Figure 66: iBGA Package Pinout

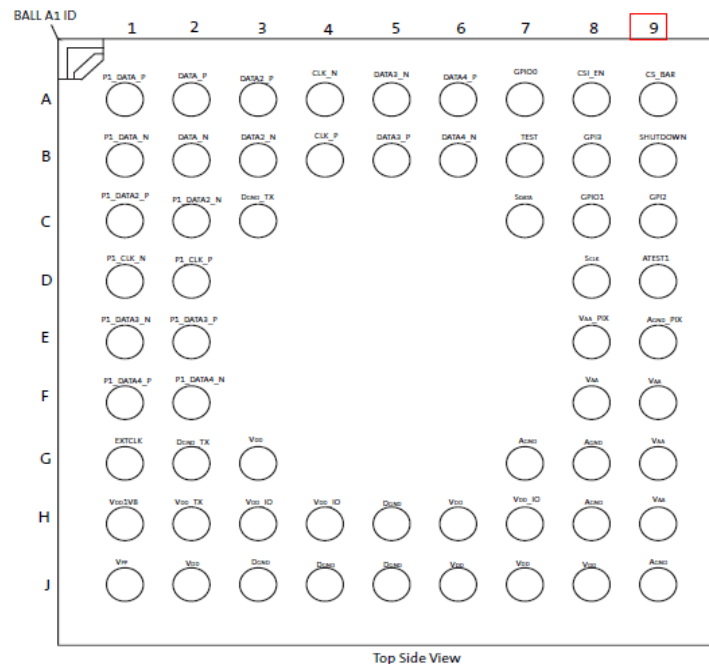
Old iBGA Package Pinout (Figure 66) with incorrect column 10 label

New iBGA Package Pinout (Figure 66) with column 10 correctly changed to column 9

Figure 66: iBGA Package Pinout

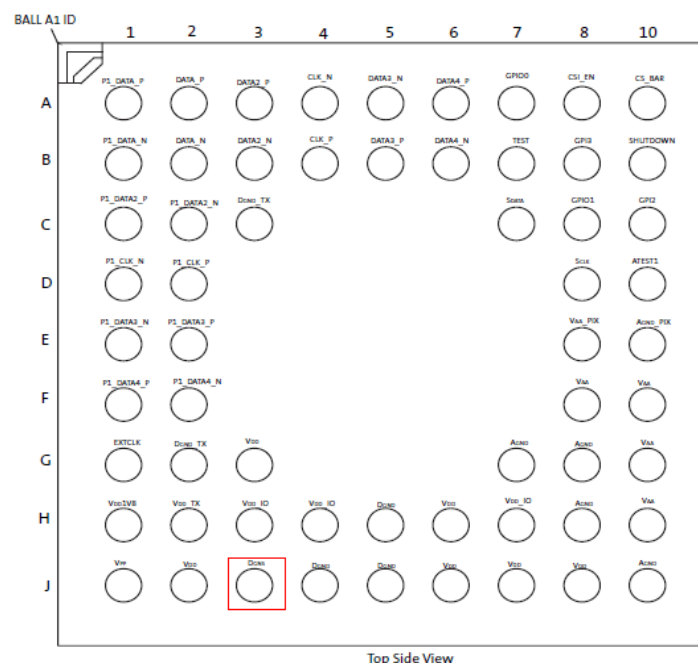
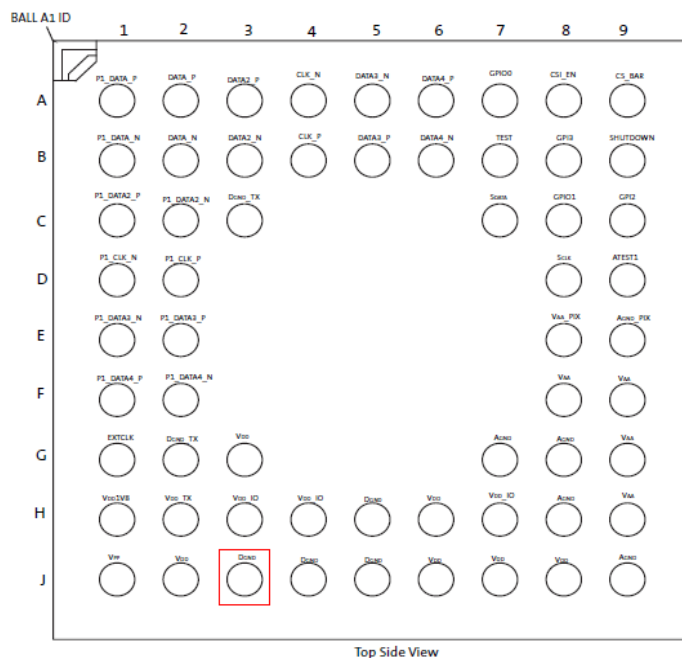
2. Change solder ball J3 from "DGNS" to "DGND"

Old iBGA Package Pinout (Figure 66) with J3 incorrectly labeled as DGNS

New iBGA Package Pinout (Figure 66) with J3 correctly labeled as DGND

This change is the result of a documentation error only; there is no change to the product form, fit, or function.
